Bridge Investigation Report

May 5, 2015

Question 1: Engineer's Specifications

Stonewall east abutment

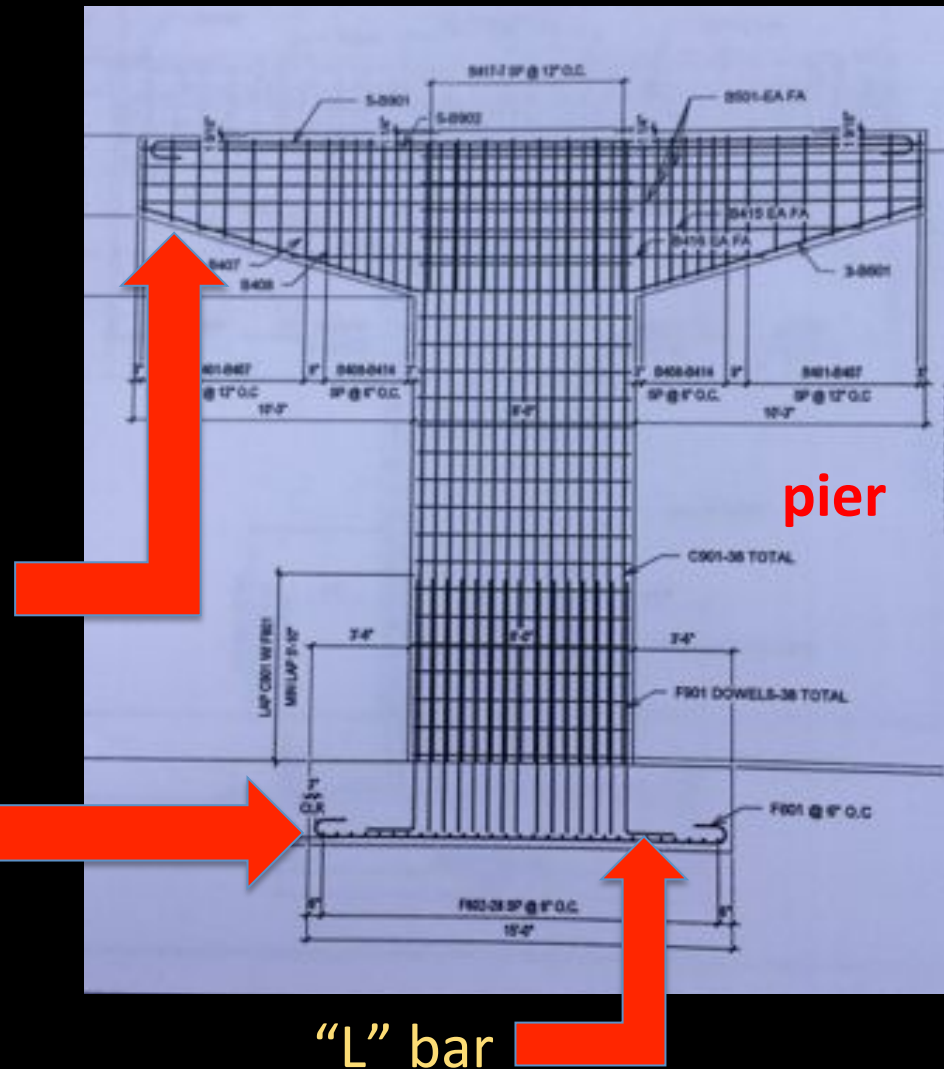
- Crews fought water and mud while digging footings. In one instance at Stonewall, they encountered a spring near a footing on the west side.
- They used pumps, but we received several reports of concrete being poured on top of mud and water.

- In some instances, when surfaces were not level, rocks were used to prop up steel mats, which is contrary to AHTD standards (although common).

Bent corners to form cage around rebar grid

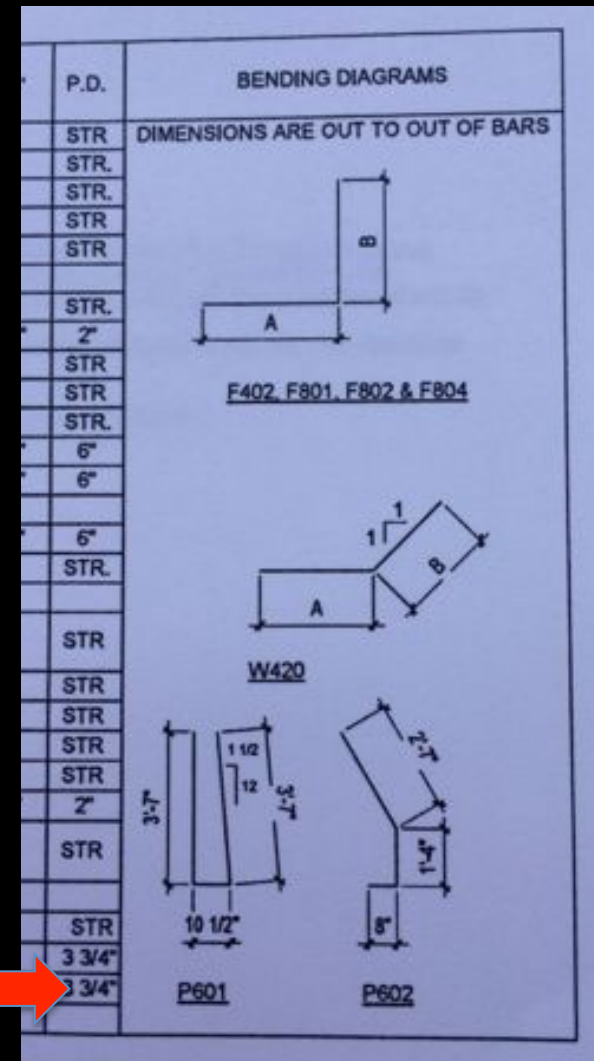
- Plans call for bent steel/rebar in multiple applications. Examples:

- Per plans, AHTD standards apply: “Bars shall be bent cold, unless otherwise permitted by the Engineer. No bars partially embedded in concrete shall be field bent, except as shown on the plans or specifically permitted by the Engineer.”
- Heat bending reduces the strength of the steel
- Plans provide specs for bending

MIN LAP 5' 10"

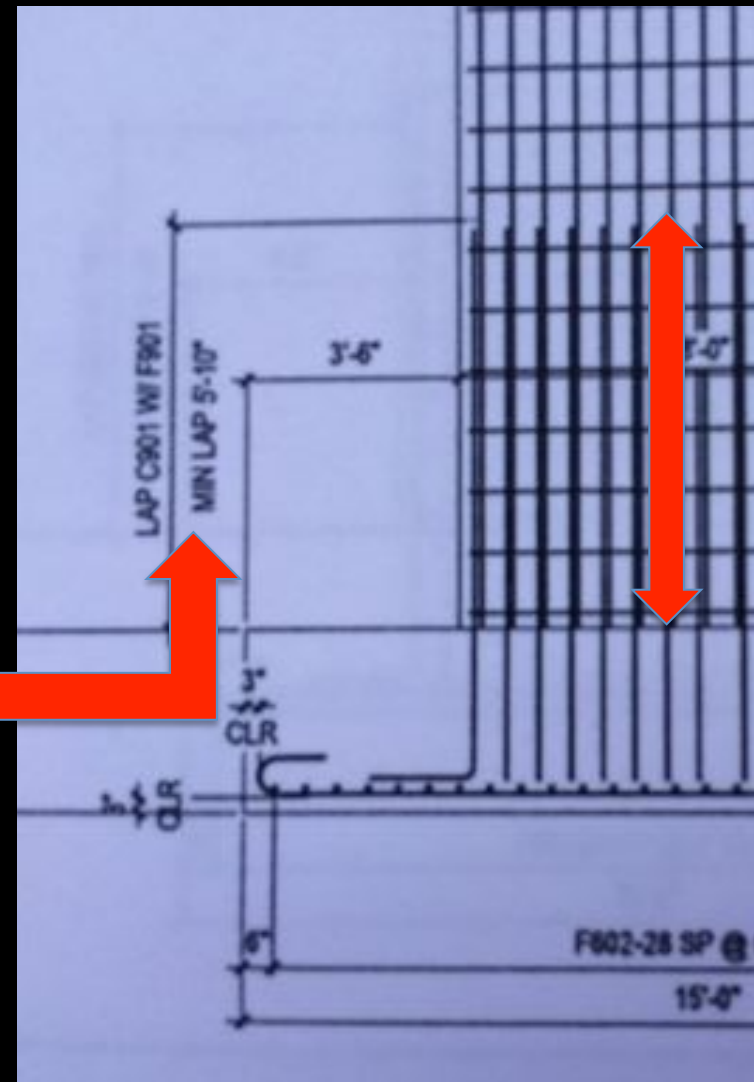
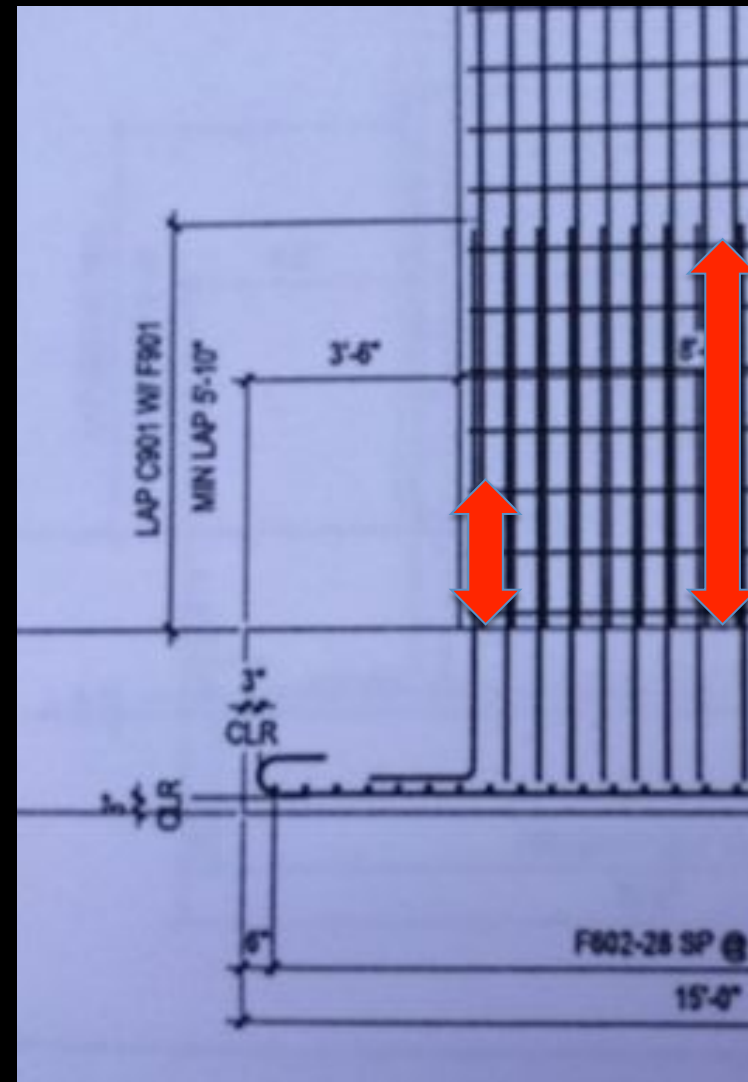
- Plans call for minimum lap lengths in walls and piers.

- Crews understood 2' or 3' was always sufficient for lap length.

Continuous Steel Rebar

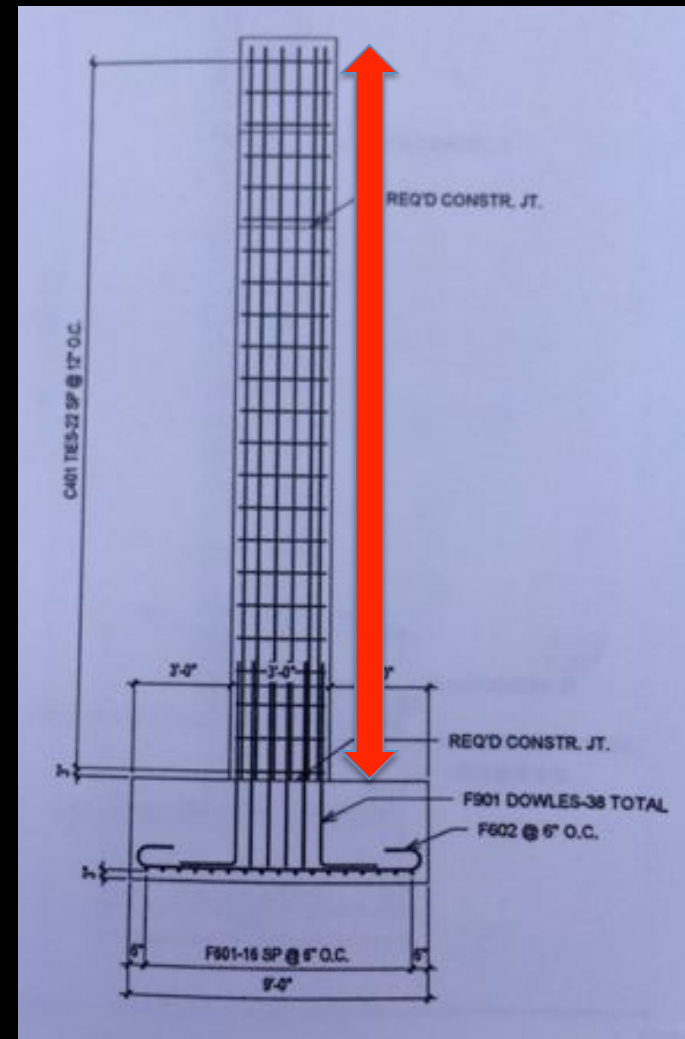
- Plans call for continuous steel bars
- Crews did not use continuous steel due to difficulty keeping it held up and prior experiences with it falling
- Lapped bars together instead

Beams and rebar left at
Stonewall site

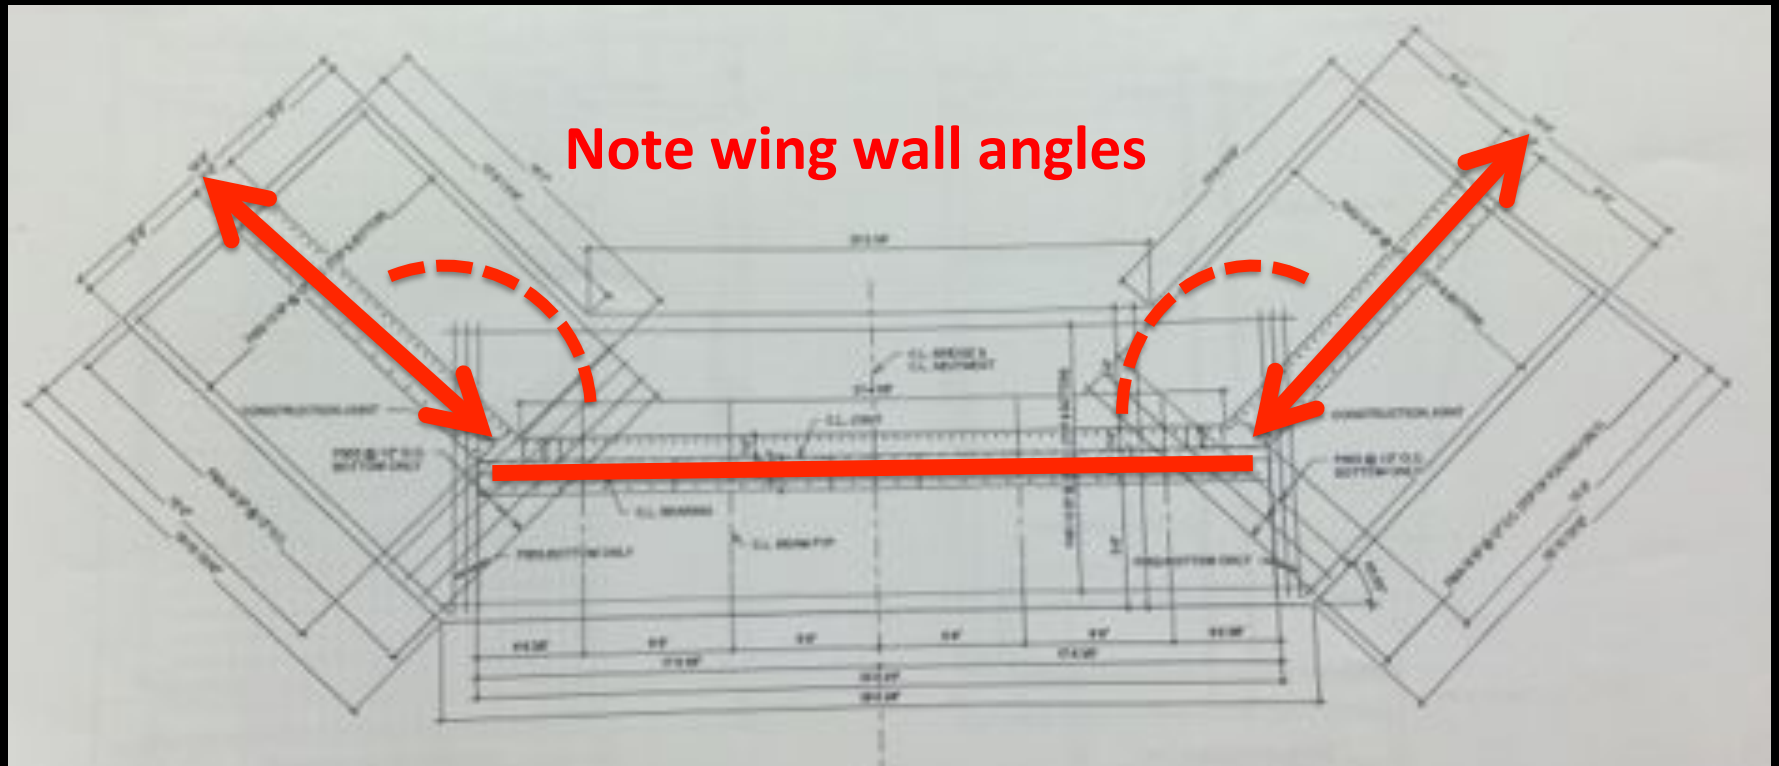
- No concrete test cylinders performed until late in process at Stonewall – done to test strength and quality
- No materials certifications
- Used red iron with no certifications

- From AHTD standards: “Steel reinforcement shall be protected from damage. When placed in the work, it shall be free from dirt, detrimental rust or scale, paint, oil, or other foreign substance.”
- “Steel reinforcement shall be stored above the ground on skids, platforms, or other supports.”

South Abutment at Harvey Dowell

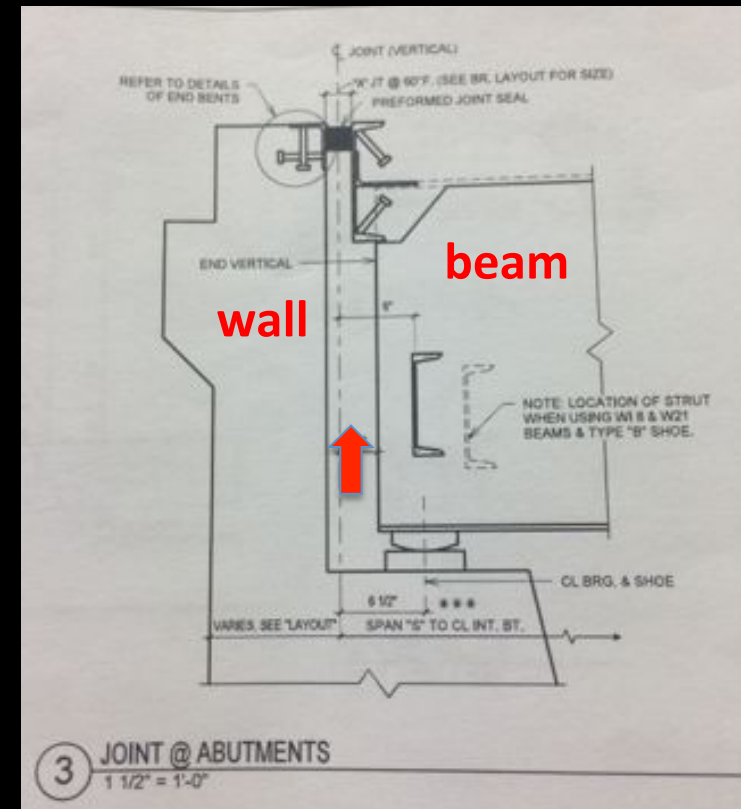
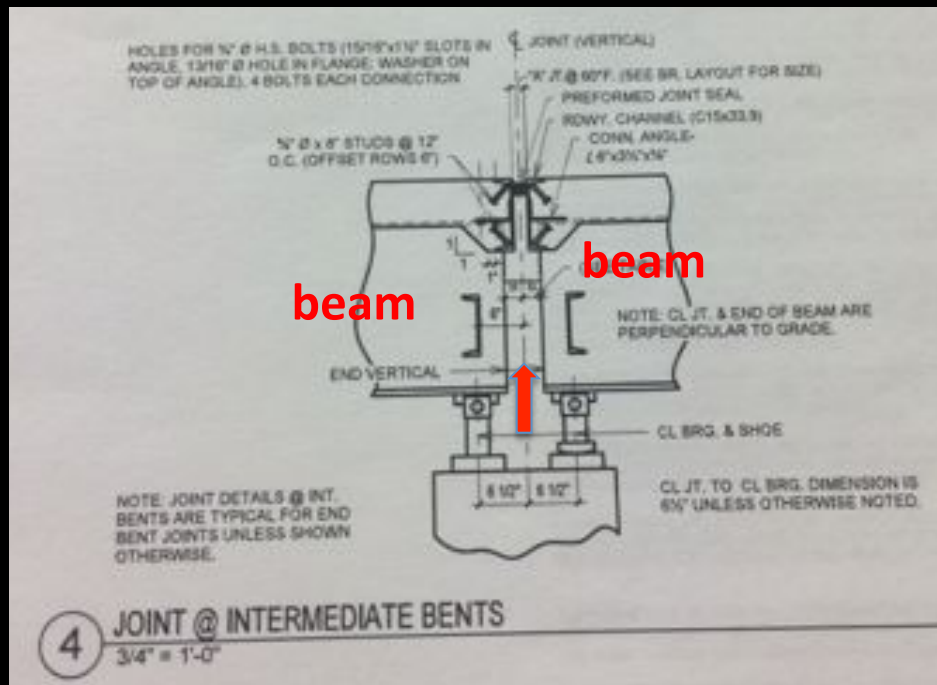
- Compare wing wall angles on north abutment, which are “to plan”

Harvey Dowell Beams

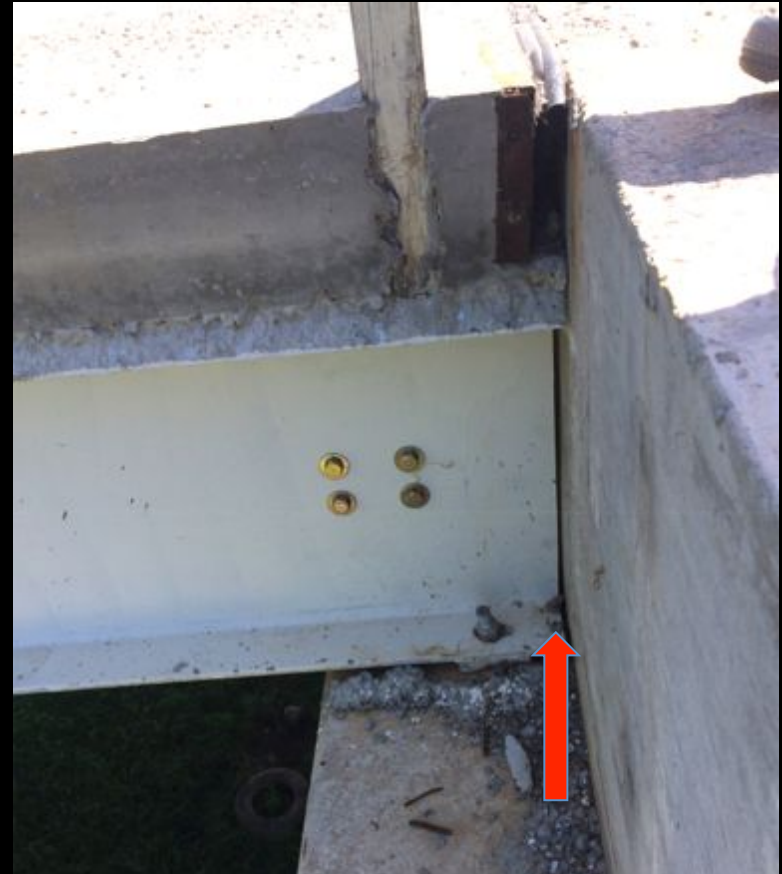
- Plans call for steel-to-concrete spacing of $1\frac{3}{4}"$ at joint abutments.

- Allows for bridge to expand/contract

From AHTD report

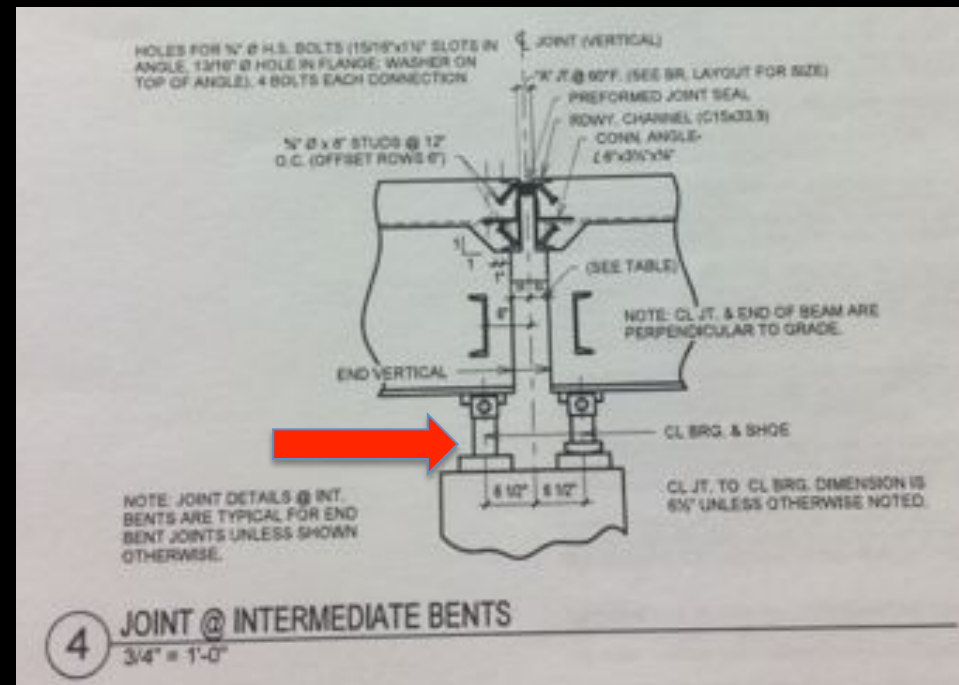
- Addressed in AHTD report in Dec. 2013 and repair made, but problem still appears today.

Harvey Dowell Beam Bolts

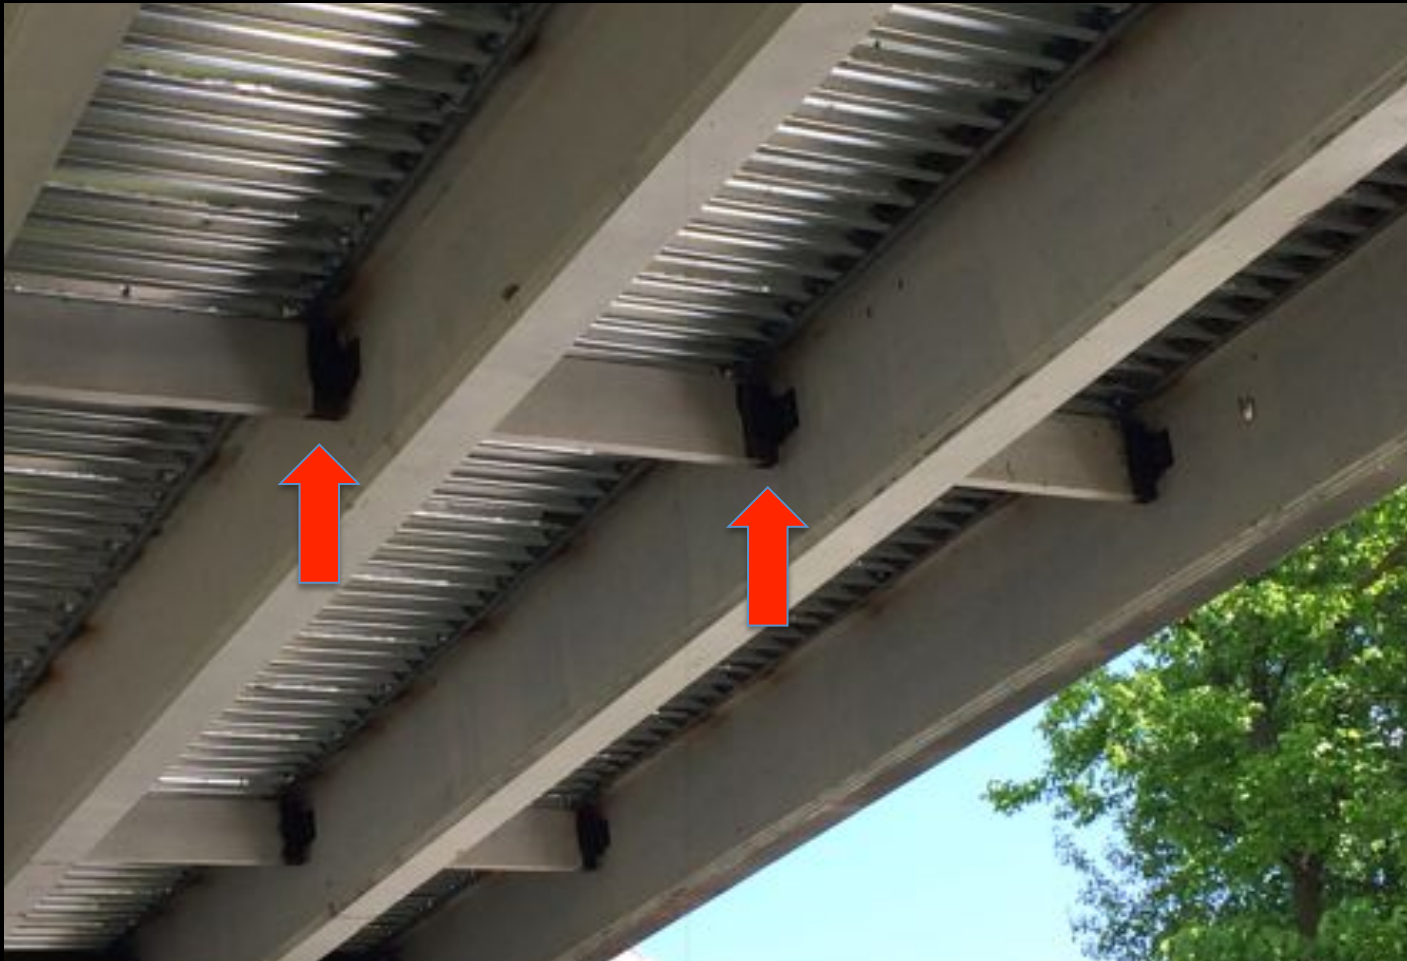
- Sleeves were not used.
- Crews attempted to drill holes in piers/abutments after the fact to affix bolts.
- Sometimes, crews encountered steel/rebar, making drilling difficult or impossible.
- Reports that two or three bolts left out. Other reports that two or three bolts were not attached to full depth.
- Loose bolts visible underneath structure.

Tine Finish

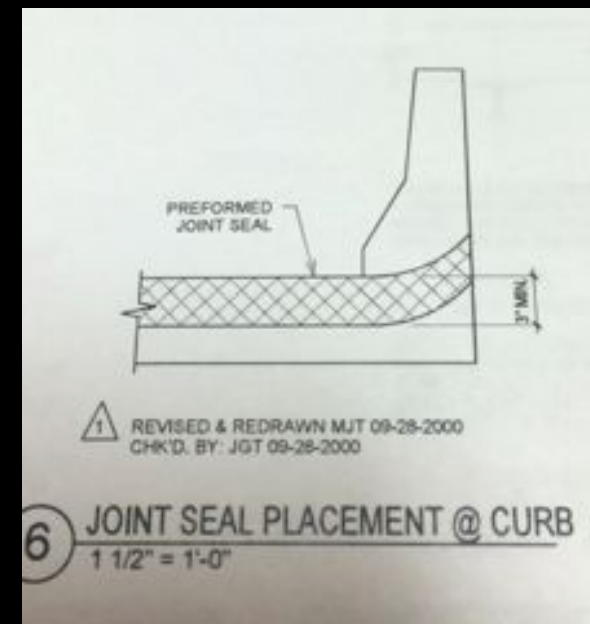
- Plans state: “Bridge deck: the concrete bridge deck shall be given a tine finish as specified for final finishing in subsection 802.19 for Class S Tined Bridge Roadway.”
- Tine finish increases safety by allowing for better traction.
- Then “Class 1 protective surface treatment shall be applied to the roadway surface,” i.e., boiled linseed oil.

County Road 62 Guard Rail

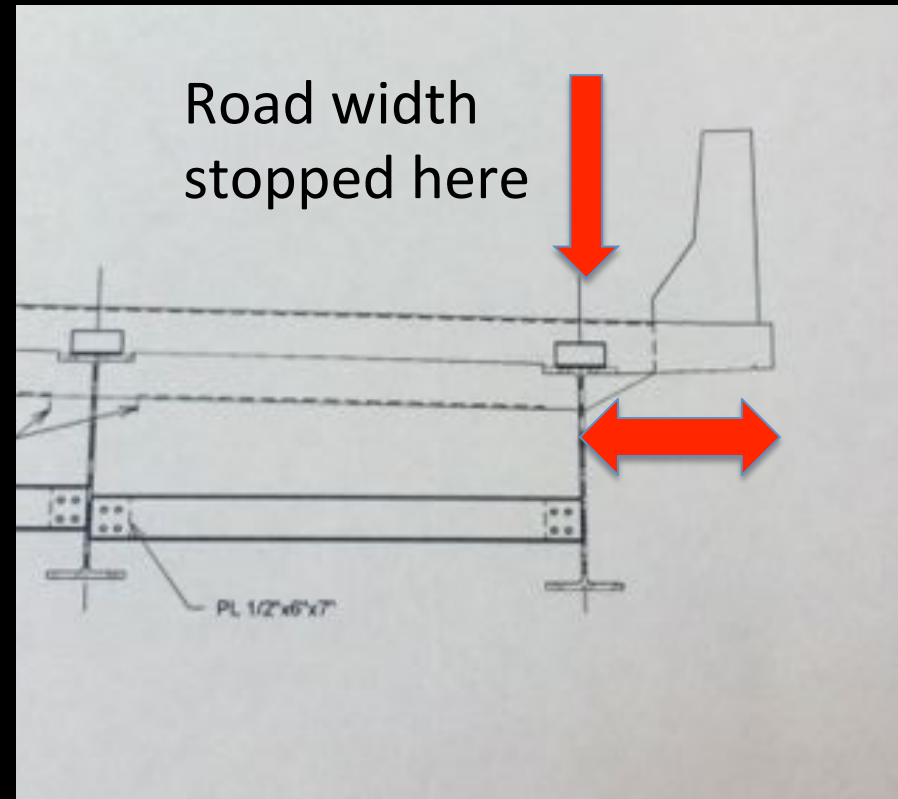
- Plans call for curbed concrete wall at road deck edge.
- No curb installed, so nothing at road edge.
- Used guard rail instead.
- Plan deviation is visible to anyone.
- Did not think they had ability (e.g., forms) to do per plan.
